QUICKSILVER
MARINE PARTS AND ACCESSORIES

No. 98-3

Cylinder Head Gasket and Torque Change

HP 425, HP 450, HP 465, HP 500 C, HP 525 SC & HP 600 SC using a Gen V or VI cylinder block and heads. Mark IV blocks do not use this gasket.

GASKET IDENTIFICATION

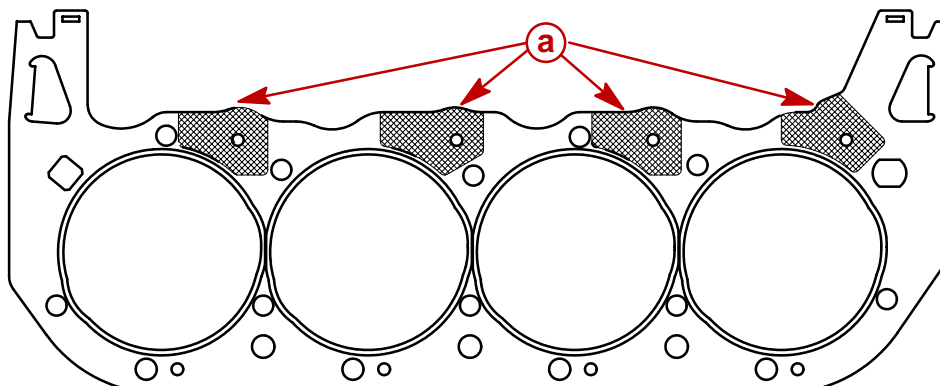
The new head gasket (27-811546--2) can be identified by the darker grey sealing material around the upper water passage holes.

a - Sealing Material Around Upper Water Passage Holes
